工程指示 / 要求簡箋 ENGINEER INSTRUCTIONS(E.I.)

工程指示編號:	EI- 8378	修改版本:	C
	HK- 1910		
工程編號:	J 861	工程名稱:	己連拿利
收件人:	生統	發件人:	細佬
工程項目:	預制窗-試模窗	日期:	21/10/2024

TITLE : TYPICAL DETAILS FOR PRECAST WINDOW

DWG NO. : J861-SD-PW-3003 REV. : A

3 VERTICAL DETAIL
70 SECTION

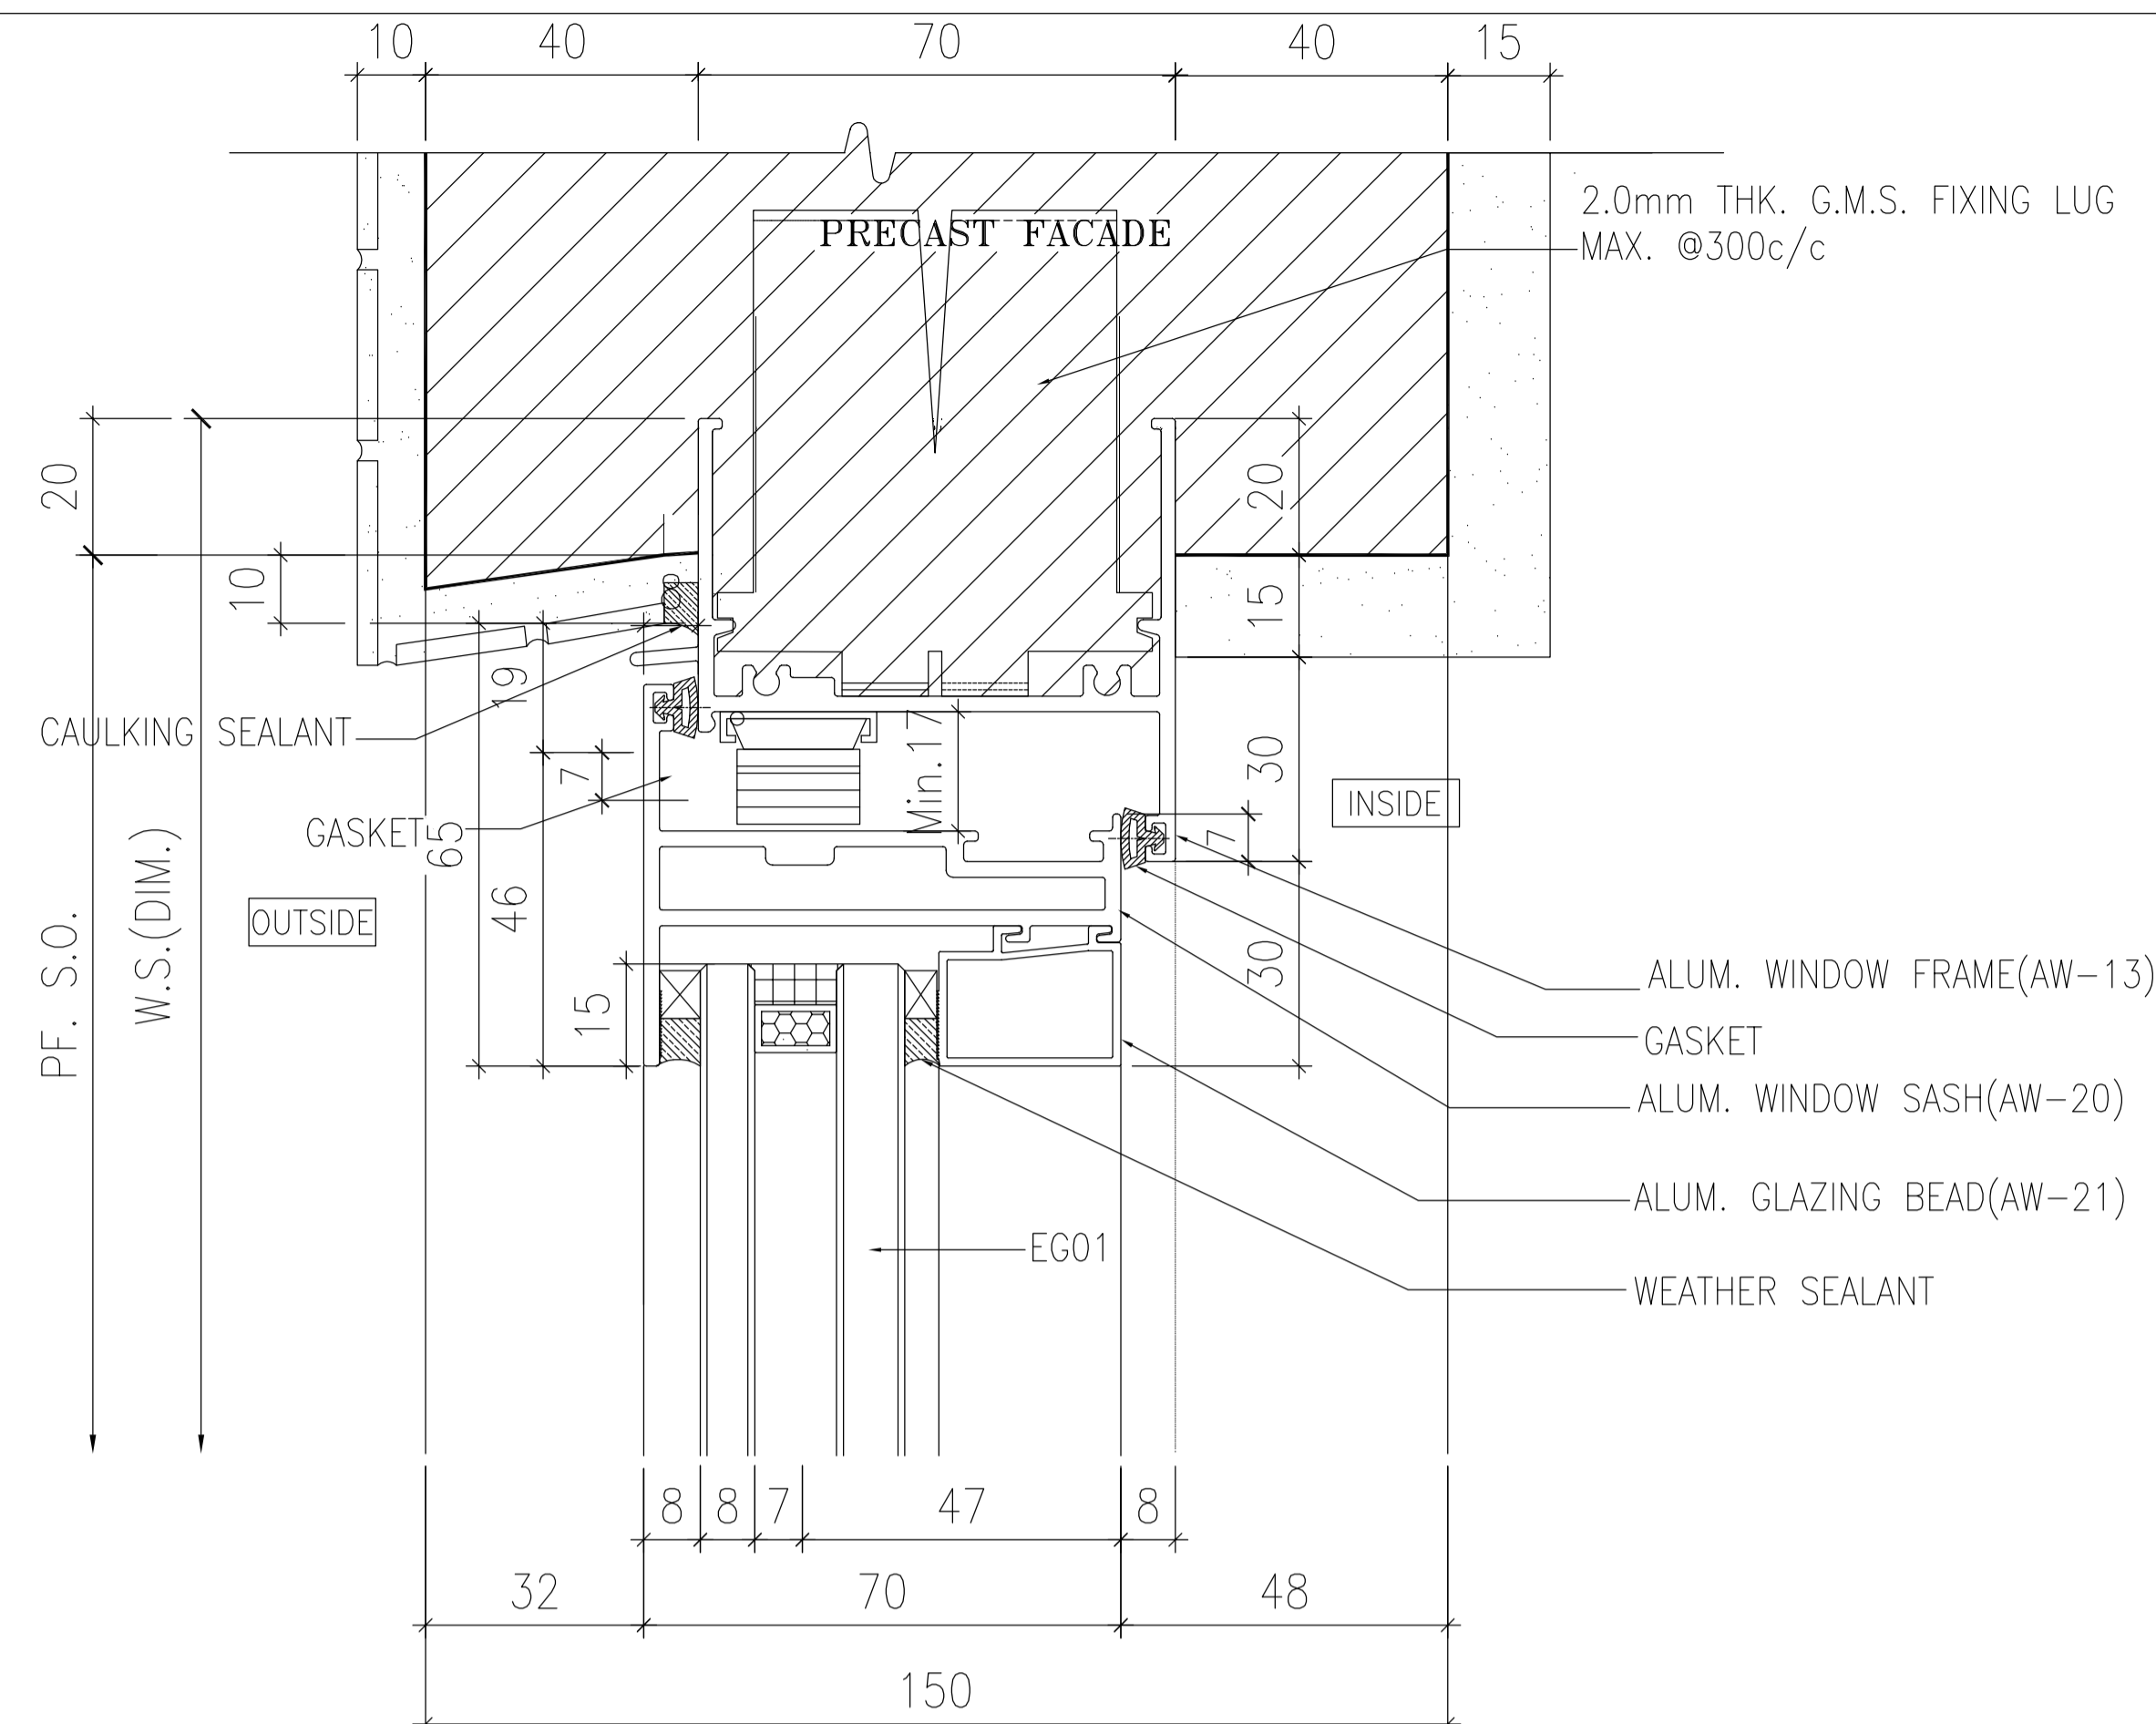
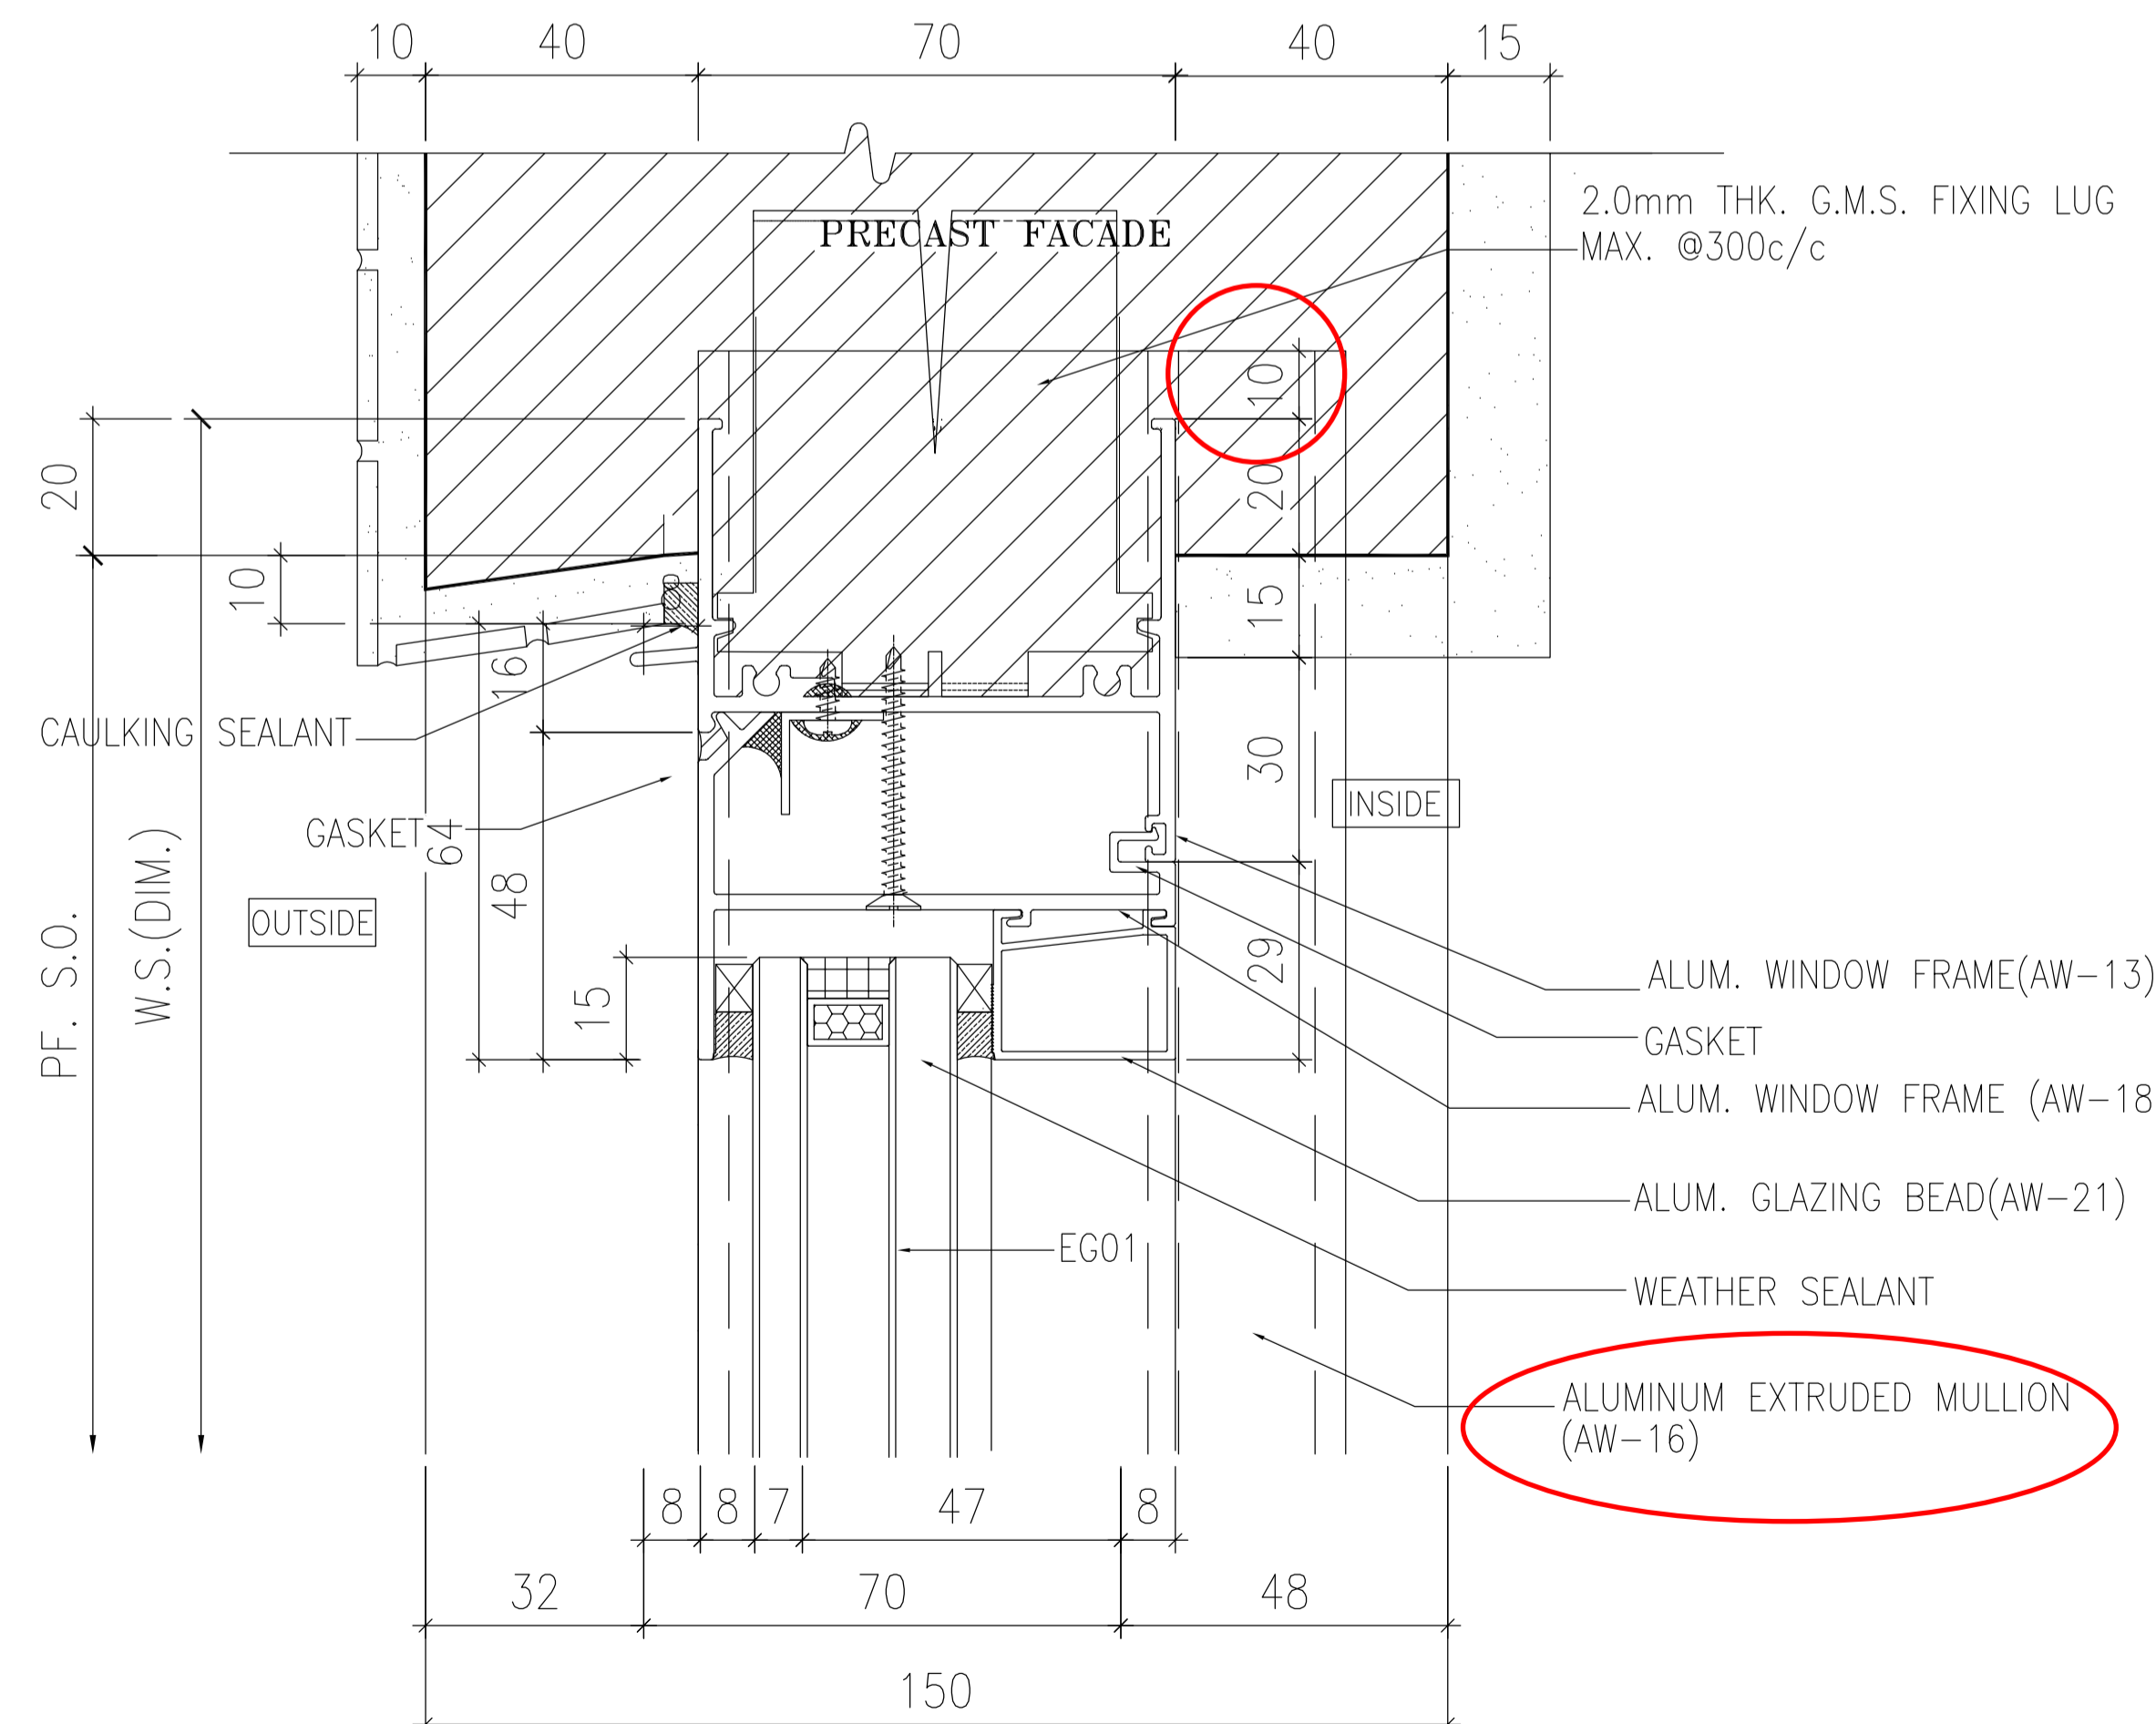
內容: 夾通要突出10mm 附頁施工圖圖號3003 試模窗的[夾通]如已開料,請按附頁方案夾通加長10mm
完成上列要求日期: 23/10/2024

試模窗 TW-07 頂底 補 10mm 夾通 方案
 夾通 補成 2580mm
